NOAA FORM 76-35A	
U.S. DEPARTMENT OF COMMERCE NATIONAL OCEANIC AND ATMOSPHERIC ADMINISTRATION NATIONAL OCEAN SERVICE	
<b>DESCRIPTIVE REPORT</b>	
Type of Survey ..Hydrographic.....	
Field No. ....RA-10-3-78.....	
Registry No. ....H-9794.....	
<b>LOCALITY</b>	
State .....California.....	
General Locality .....San Francisco Bay.....	
Sublocality .....Yerba Buena Island to.....	
.....Brooks Island.....	
<u>1978</u>	
<b>CHIEF OF PARTY</b>	
.....CAPT. J.P. Randall.....	
<b>LIBRARY &amp; ARCHIVES</b>	
DATE .....July 8, 1981.....

NOAA FORM 77-28 (11-72)		U.S. DEPARTMENT OF COMMERCE NATIONAL OCEANIC AND ATMOSPHERIC ADMINISTRATION	REGISTER NO.
<b>HYDROGRAPHIC TITLE SHEET</b>		H-9794	
<b>INSTRUCTIONS</b> - The Hydrographic Sheet should be accompanied by this form, filled in as completely as possible, when the sheet is forwarded to the Office.		FIELD NO.	RA-10-3-78
State <u>California</u>			
General locality <u>San Francisco Bay</u>			
Locality <u>Yerba Buena Island to Brooks Island</u>			
Scale <u>1:10,000</u>		Date of survey <u>Oct. 6 to Nov. 22, 1978</u>	
Instructions dated <u>10 August 1978</u>		Project No. <u>OPR-L123-RA-78</u>	
Vessel <u>NOAA Ship RAINIER Launches RA-3 (2123), RA-5 (212

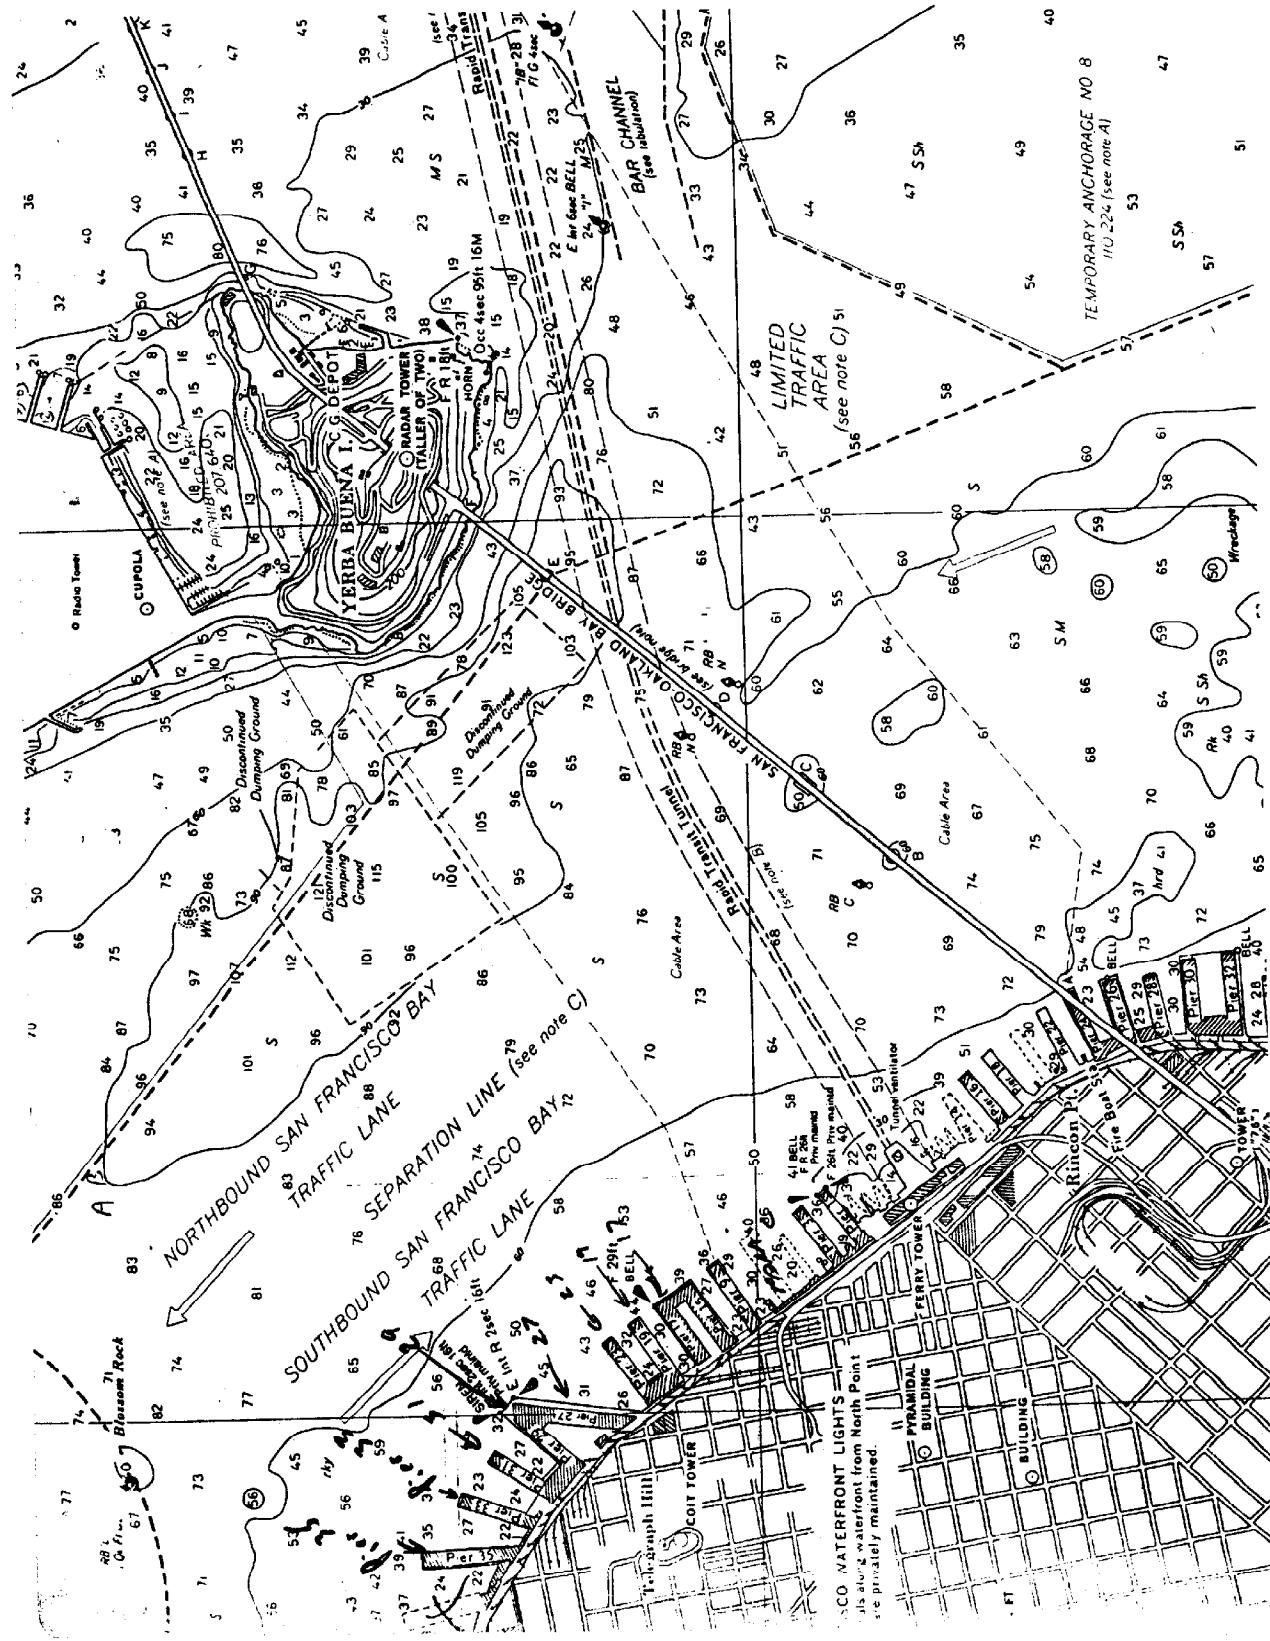
SHOW ALL CABLES ON PHOTOS

ARE THESE OBJECTS SHOWN AND LABELED CORRECTLY
